REQUEST FOR TECHNICAL REVISION (TR) COVER SHEET

File No.: M- 1996-096 Site Name: Glacier Rock Mine
County Larimer TR# _____ (DRMS Use only)
Permittee: Glacier Rock Gravel Company
Operator (If Other than Permittee): NA
Permittee Representative: Kyle Regan

RE: Technical Revision – Glacier Rock Mine (Permit M-1996-096), Larimer County, Colorado

MINE PLAN
MAP

EXHIBIT C

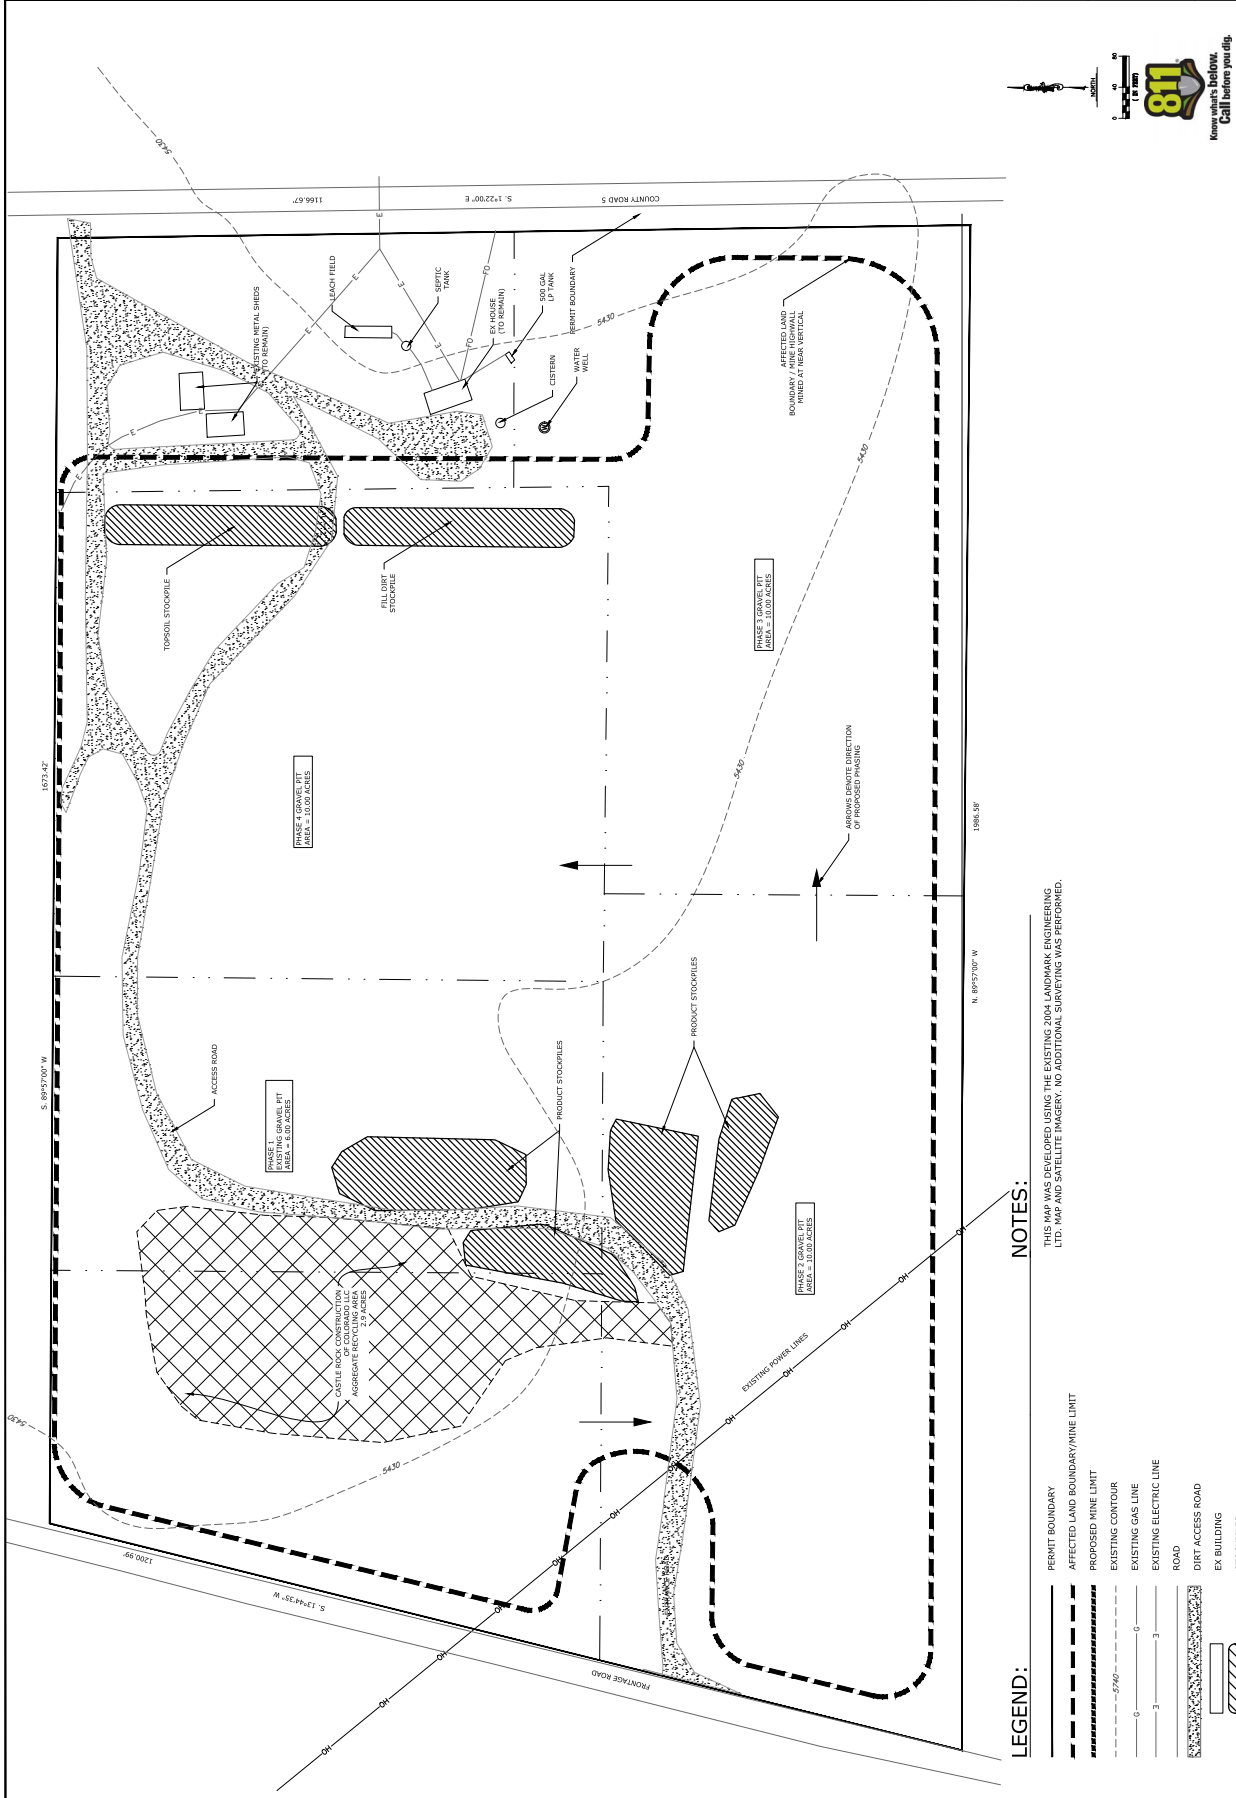
PROBLEM #2: Portions of areas that have been reclaimed were found to be re-disturbed by an aggregate recycling yard operation. This is a problem for failure to follow approved reclamation plan, or current reclamation plan needs to be updated and clarified pursuant to C.R.S. 34-32.5-116 (1). The Operator must follow approved reclamation plan or provide sufficient information to describe or identify how the Operator intends to conduct reclamation.

CORRECTIVE ACTIONS: The Operator shall submit a Technical Revision, with the required \$216 revision fee, to update and clarify the current approved reclamation plan to reflect existing and proposed activities, including the details of the lease agreement with the Castle Rock Construction of Colorado LLC for the aggregate recycling operation by the corrective action date.

Castle Rock Construction of Colorado, LLC has a lease with the Operator to use the northwest portion of the Site(see Attached). The Operator agrees with the Division's estimation of 2.9 acres of formerly reclaimed area that have been re-disturbed. This 2.9 acres has been added to the mining plan map(see Attached). The 2.9 acre area will need to be reclaimed with 6-inches of topsoil and reseeded according to the approved plan after cessation of activities.
